City of Enumclaw Pool Evaluation

October, 2017

*Prepared by:
Aquatic Commercial Consulting
Richard A. Young, Aquatic Consultant
408-741-5871 // richy@aquacom.us*

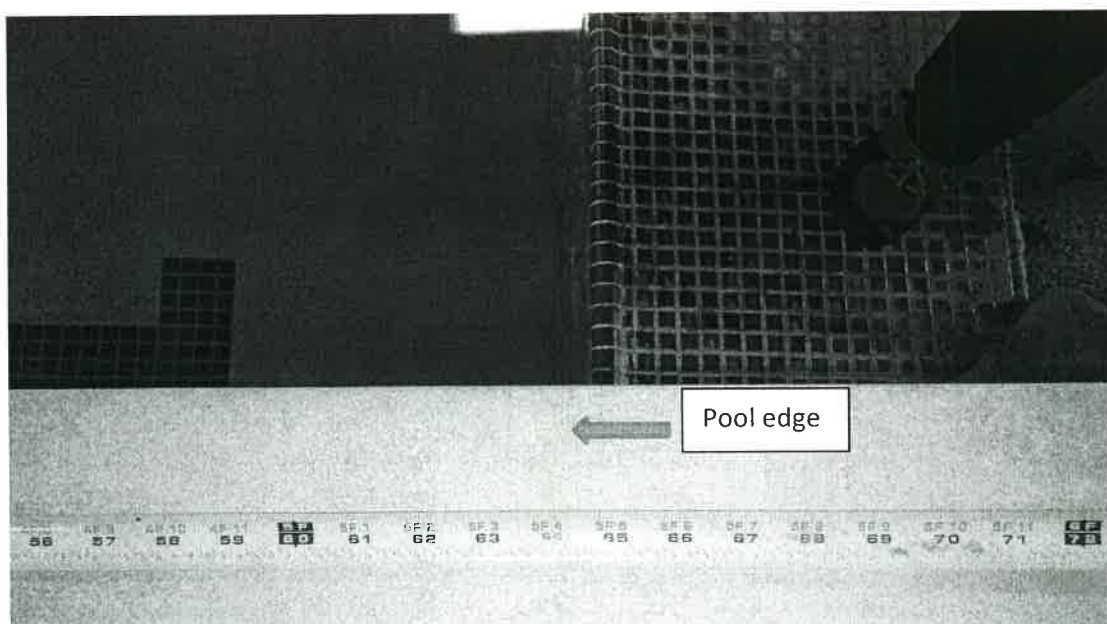
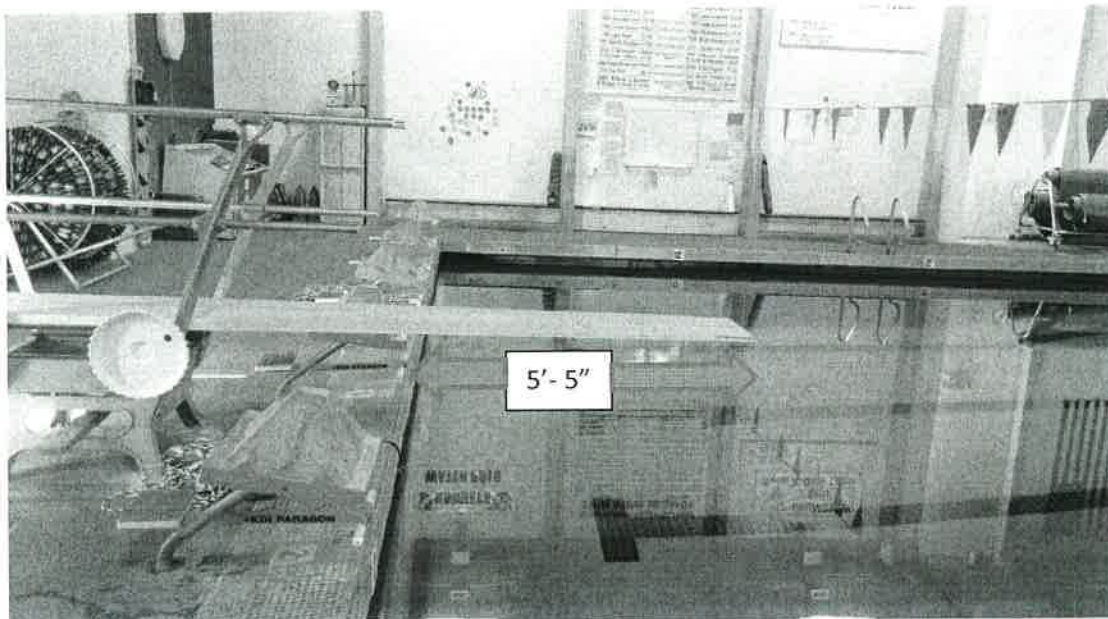
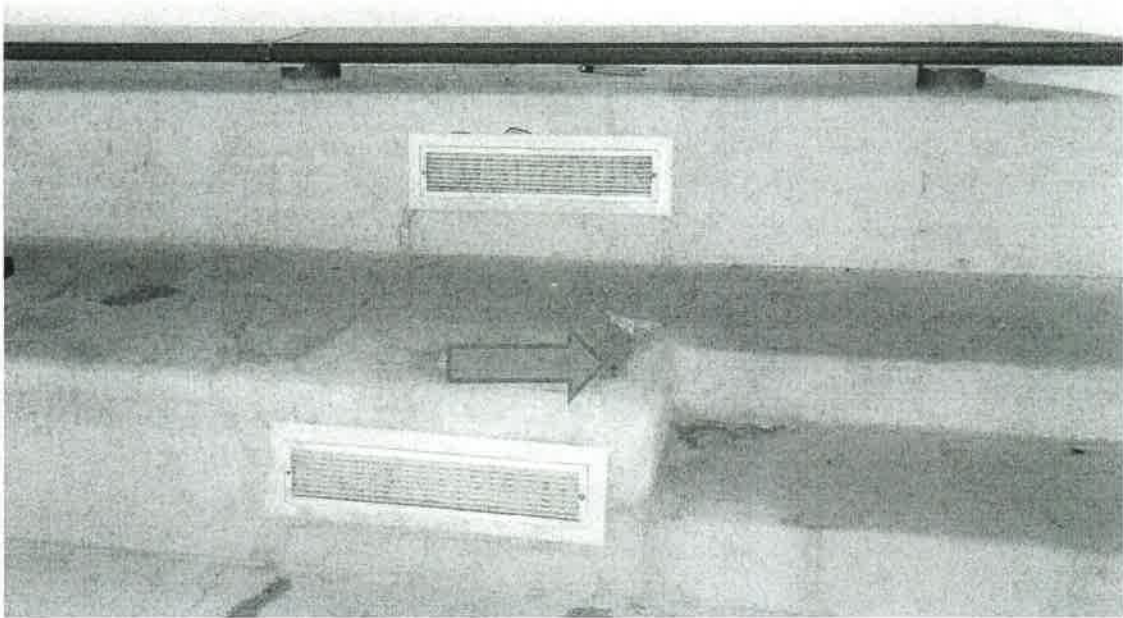
13. The diving board stand is set too far away from the pool edge and the diving board does not extend the code required six (6) feet beyond the pool edge per WAC, FIMA, NFHS

and IS. The board end is only 5'- 5" beyond the pool edge and only 5' beyond the vertical pool wall "standing" ledge.

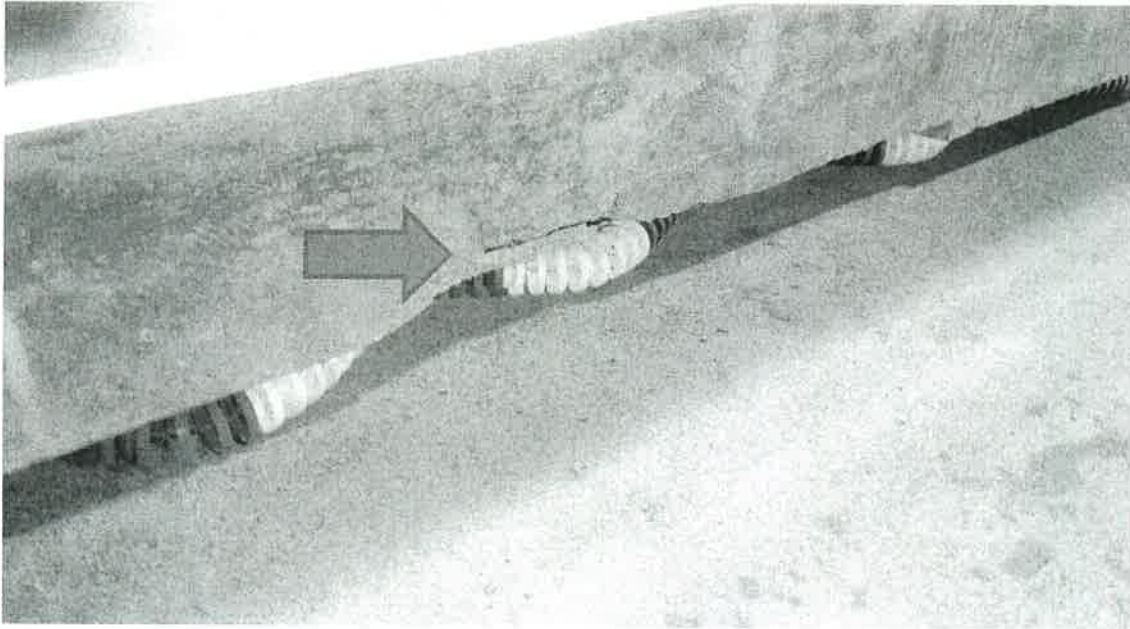
14. The seating area concrete and rail footing has failed in several areas with several cracks and voids. The seating area concrete is also cracked in several places.

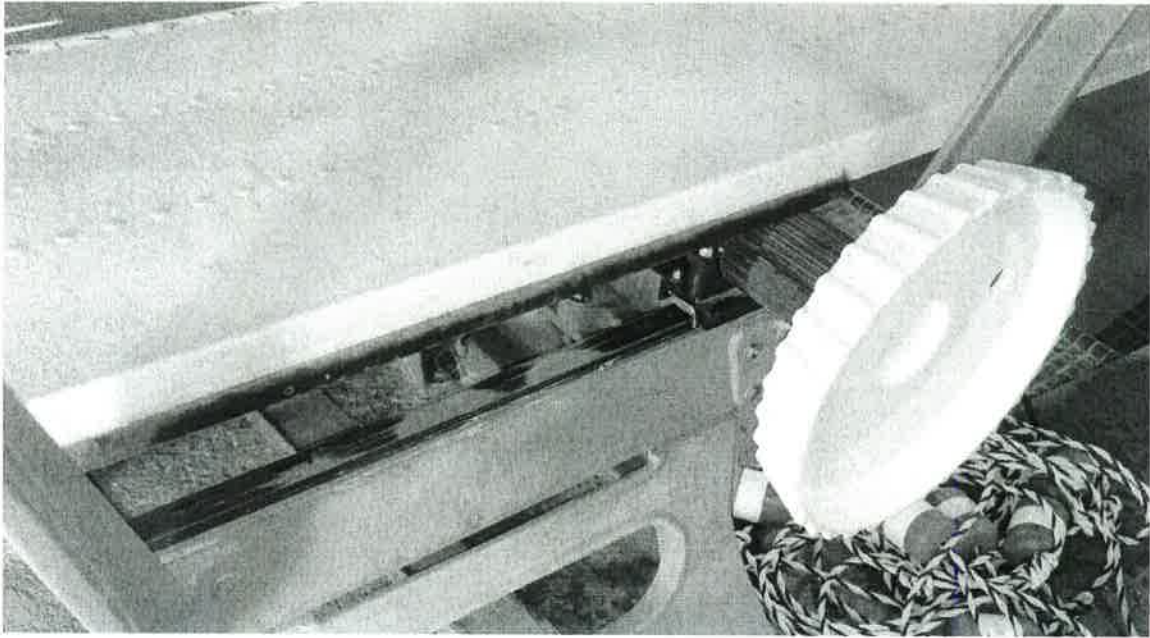
17. The diving board fulcrum and hinges do not appear to have been lubricated for some time IS.

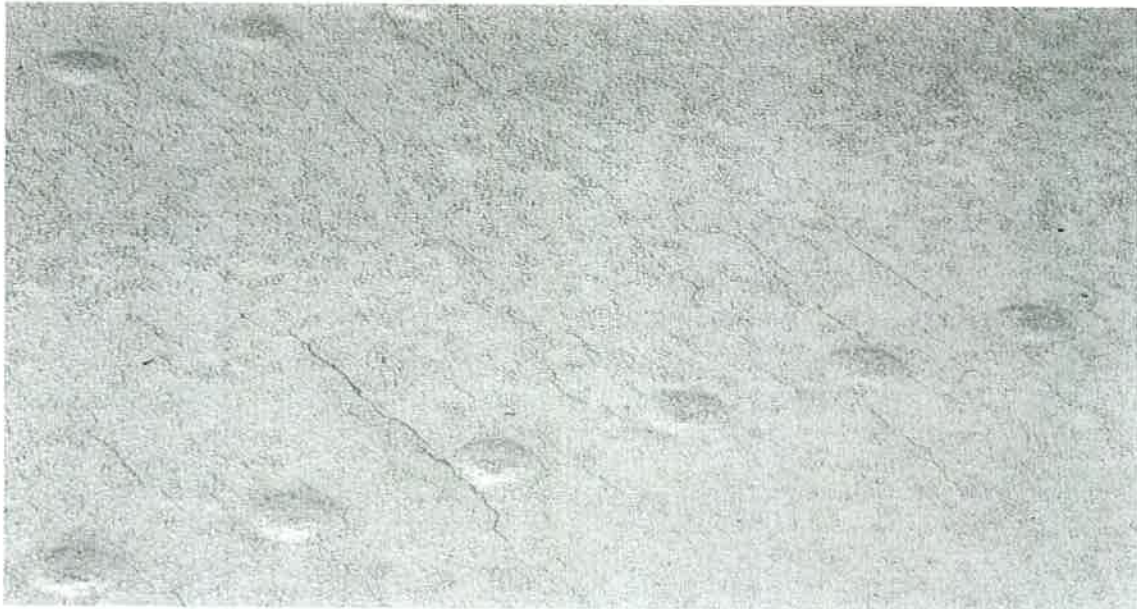
18. The adjustable fulcrum was found to be in the forward position but is not locked in place per ARC lifeguard training manuals to prevent inexperienced users from using the board in an unsafe manner.

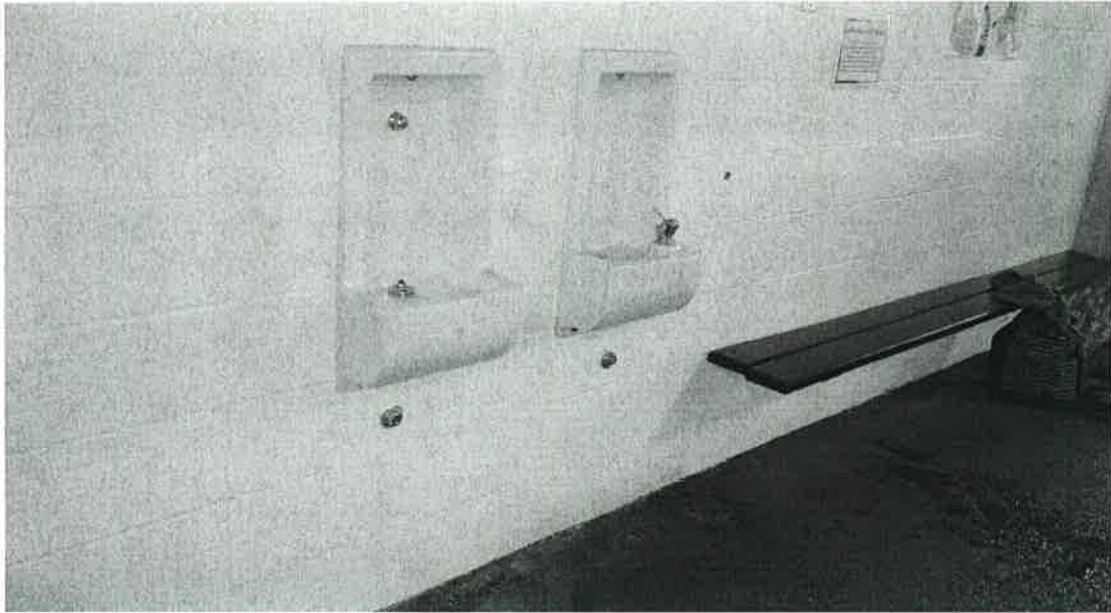
19. The diving board surface is delaminating and part of the board coating is peeling.

1. Remove and send the board back to Duraflex to have it re-surfaced
Estimated Cost: \$ 3,000
2. Lubricate the board hinges and fulcrum
Estimated Cost: Nominal
3. Install a stainless steel cable and water-resistant lock for the fulcrum
Estimated Cost: \$100

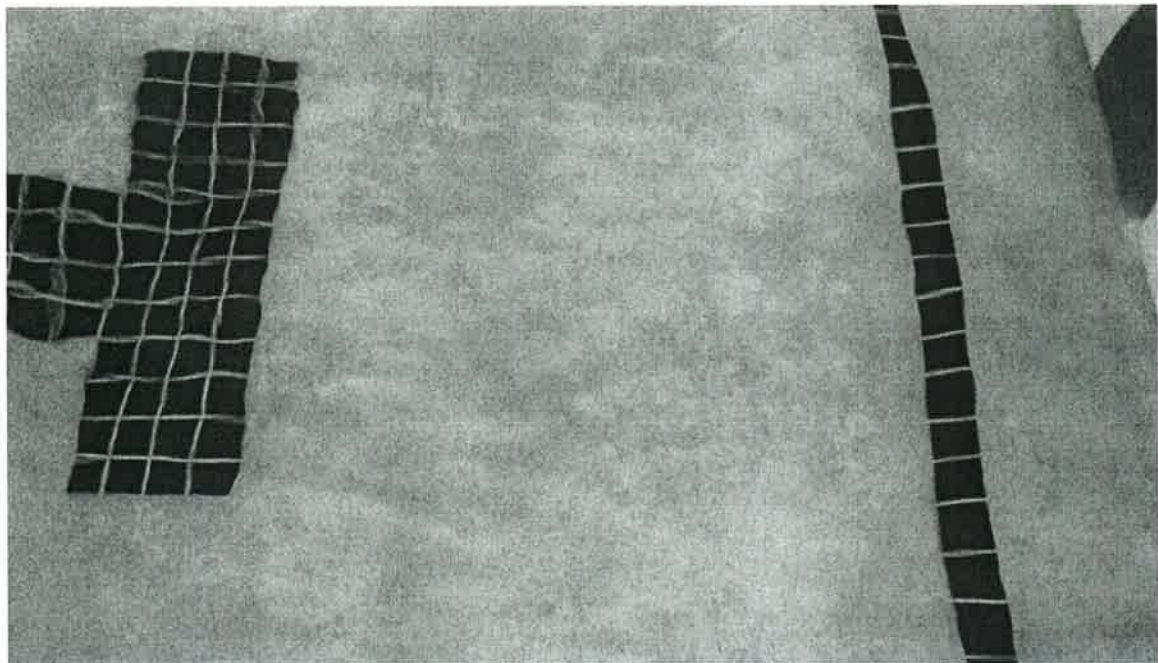
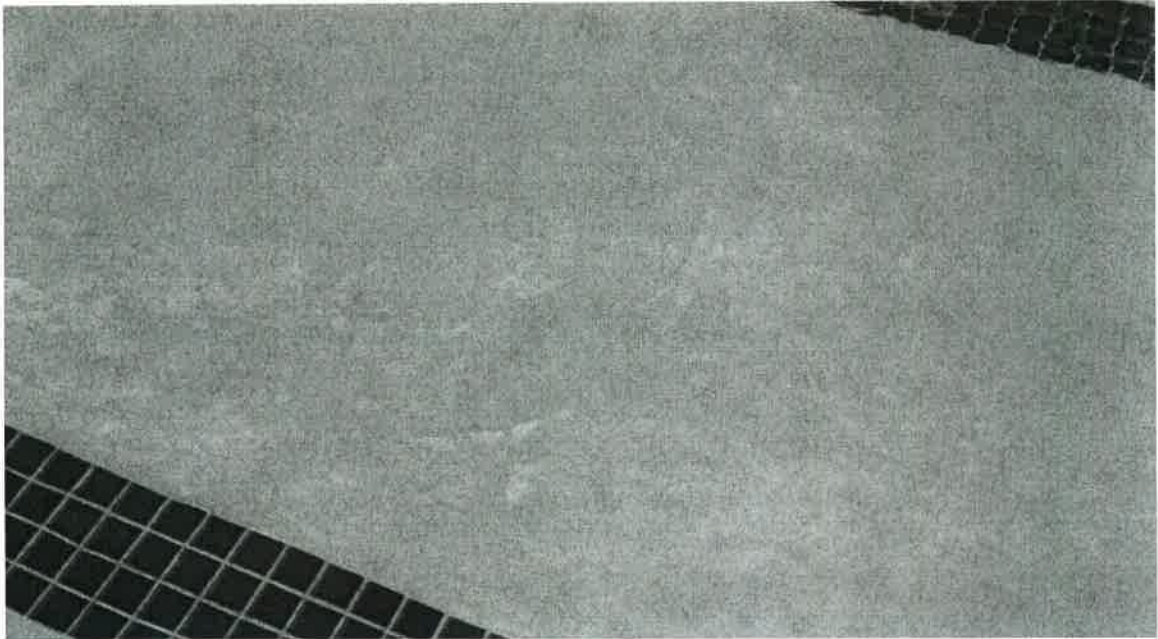
22. There is a safety line on the bottom of the pool at the 4.5' depth in compliance with the WAC, however, the code also calls for a rope with floats with recessed wall anchors to provide a location for a rope with anchors to be attached. NAHC and IS call for this safety line.

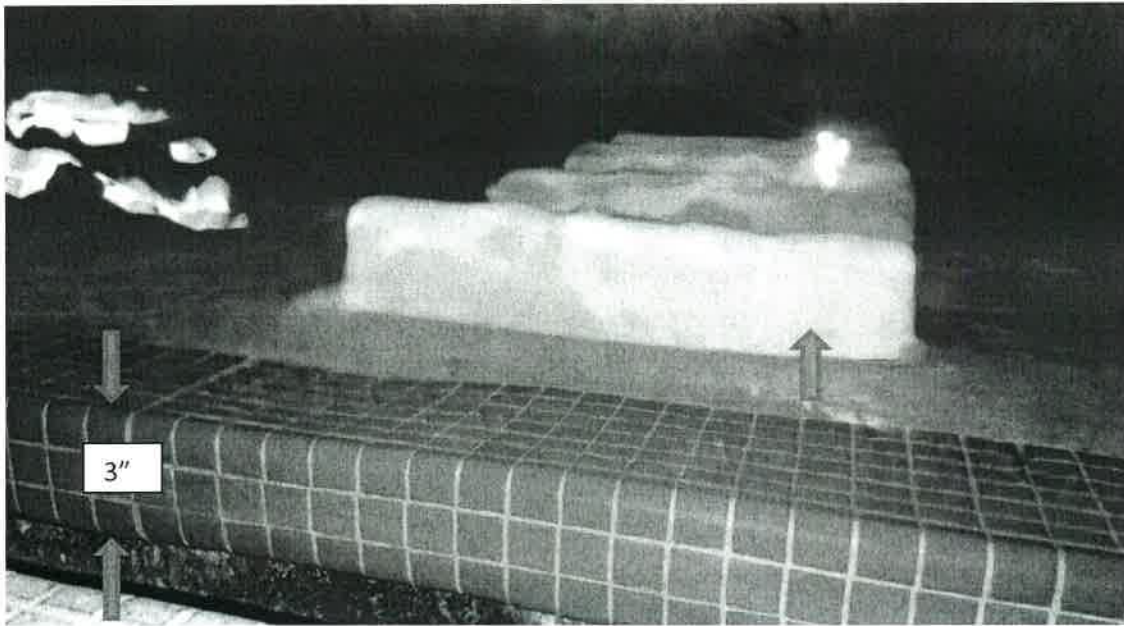
1. The pool plaster is well stained and has several areas with plaster patches. Plaster cracks and several voids are visibly evident.

4. The hand hold is 3” wide falling short of industry standards and the National Aquatic Health Code recommendations of a maximum of 2.5”. (see above photo)
5. The grout in the water-line and gutter tile is well stained and is missing in some areas.
6. Staff must move portable platforms in and out of the water for teaching lessons and there is a fiberglass step for those needing steps for entry and leaving the pool. This pool does not offer young children an areas to swim as the pool most shallow point is 3.5 feet which slopes to 4 feet and more. Staff expressed a desire to eliminate the fiberglass steps and also provide zero depth entry.

1. The listed issues make it clear the pool is ready for re-coating.
2. The repairs to the steps can be completed at that time, or can be repaired under water by an experienced diver.
3. The repairs to the “bleeding” rebar must also be addressed.
The rebar must be fully exposed, wire brushed and ground to bare metal and epoxy coated. Once cured, the area patched with plaster or non-shrink grout. This can be accomplished underwater by an experienced diver.
4. Remove one row of tile around the gutter lip on the gutter side and grind smith to provide an industry compliant hand hold.
5. Remove all old plaster and re-plaster the entire pool, re-grouting all tile surfaces.

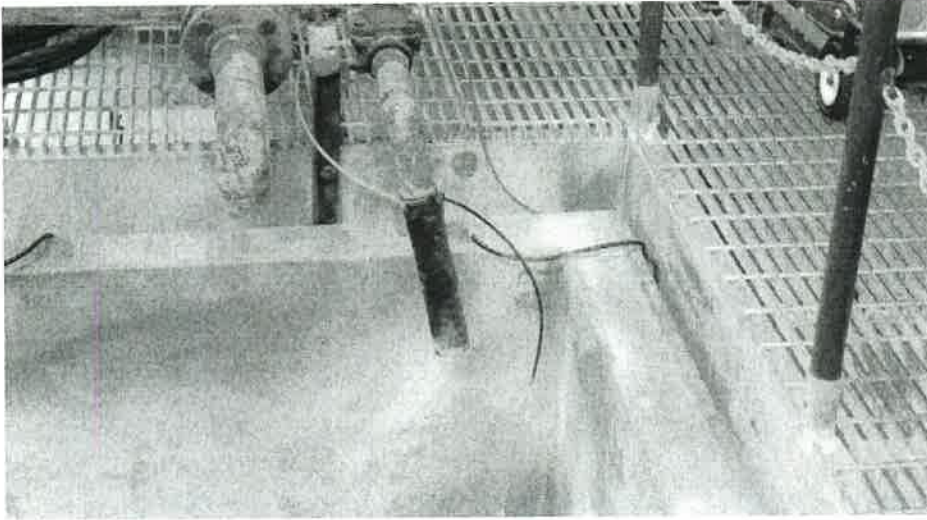
4. The D.E. pre-coat tank is comprised of a converted 50 gallon trash can.

Recommendation: Install a new fiberglass or polyethylene tank of approximately 150 to 200 gallons with a 2" drain valve for pre-coating the filters, a slow speed mixer and industrial-grade solution feed pump with an automatic flush device to "body" feed D.E. into the surge/filter pit 24 hours per day.

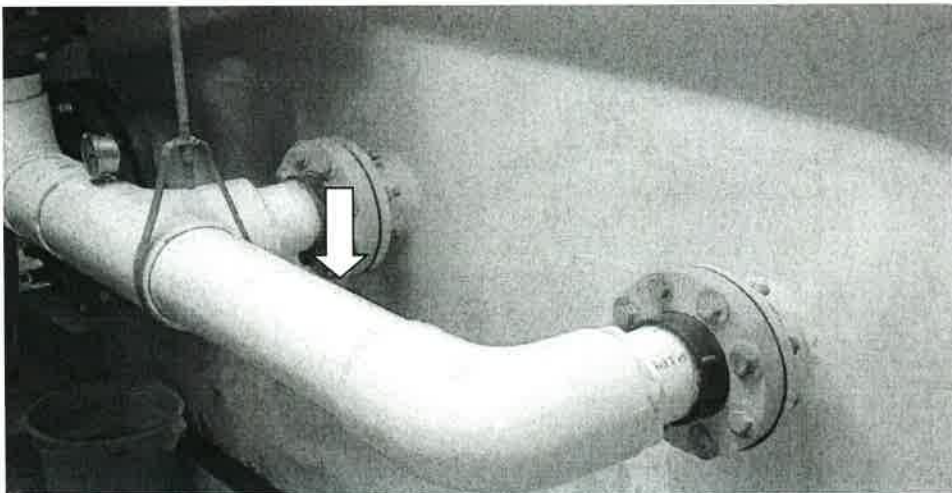
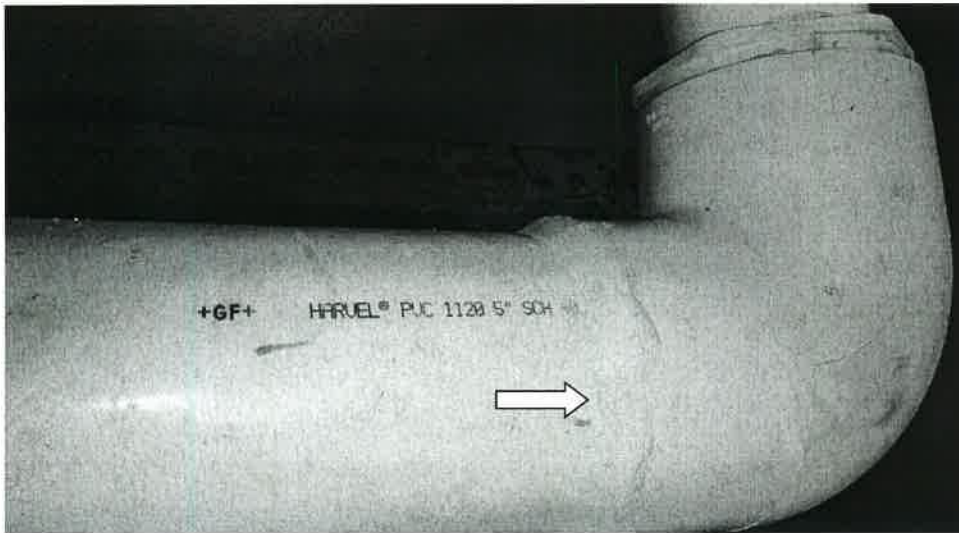
7. The suction manifold from the filter to the pump is only 5 inches and is undersized for the flow rate for this pool. The industry standard for maximum flow for 5 inch suction pipe (6-7 feet per second) is approximately 450 GPM, measurably short of the WAC design flow rate needed.

This manifold has also developed a leak which has been patched with epoxy.

Recommendation: Install a new 6" manifold with 6" x 4" tee and 90 degree elbow to decrease the suction velocity to below 6 feet per second. Connect to the pump with a concentric reducer to the 5" flange at the pump. With the limited space this will require some additional plumbing to achieve the proper plumbing connections.

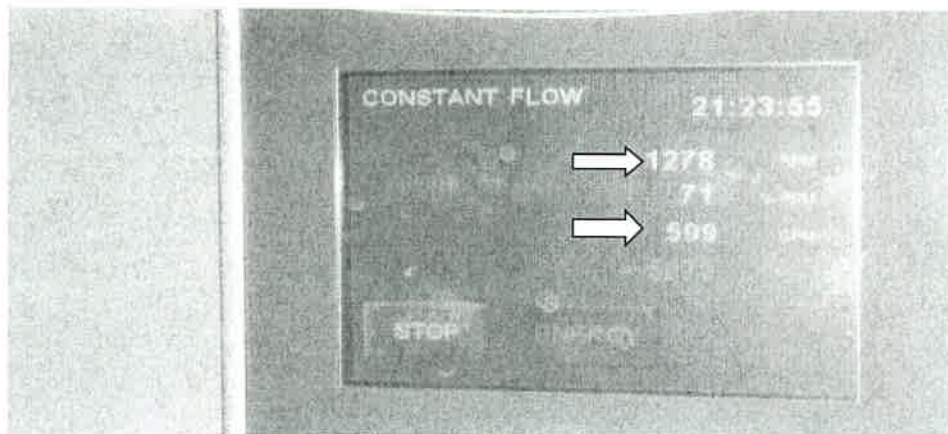
8. The pump discharge flange is four inch and connects to 4 inch plumbing. The maximum flow in 4 inch pipe is only 400 GPM, however, the short section of 4 inch pipe allows for the higher flow rate now being achieved. A connection to a concentric reducer would be far better and allow for high flow rates. The amount of filter area does limit the flow and the present setting must remain until changes can be made to the filter.

Recommendation: Install a concentric 4" x 6" reducer at the 4" flanged pump discharge port to eliminate the 4" plumbing. Because of the limited space, this may require some minor plumbing changes to the existing lines.

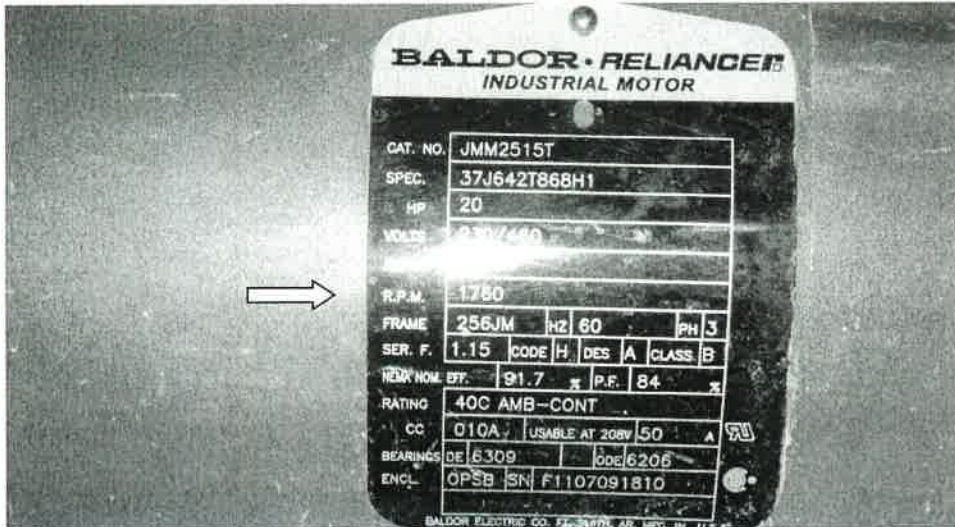
11. According to this display, the pump is only operating at 1,278 RPM, yet is capable of 1,750 RPM allowing for a higher flow that may very well achieve the WAC required flow rate to achieve the six hour turnover.

Recommendation: Upon increasing the pump suction manifold and discharge plumbing changes, reprogram the VFD to operate at a higher RPM to achieve the 680 GPM WAC-required recirculation flow rate.

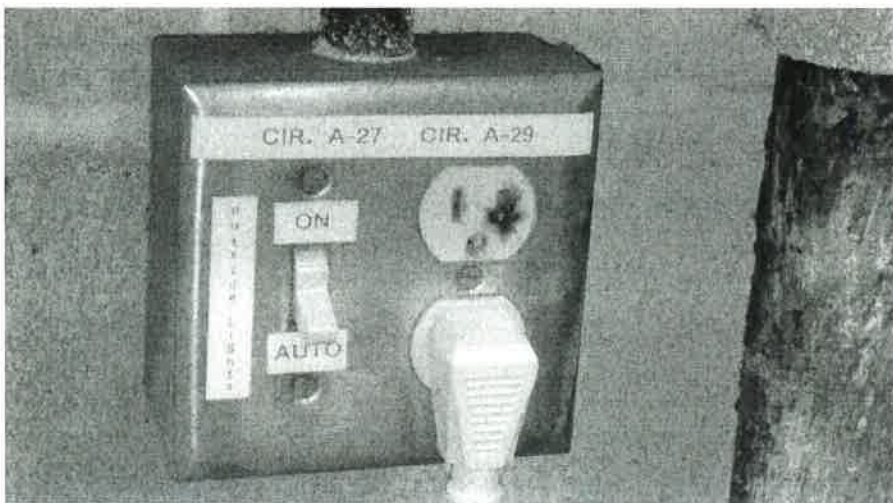
The filter/surge tank is a coated steel tank that appears to be in good shape, however, this tank sits on flanged supports onto the concrete floor. The supports are significantly corroded.

Recommendation: Remove the rust and corrosion and inspect the flange supports for integrity. Paint the flanges and supports with an epoxy paint to protect them from further corrosion. Replace them and the concrete anchors if necessary.
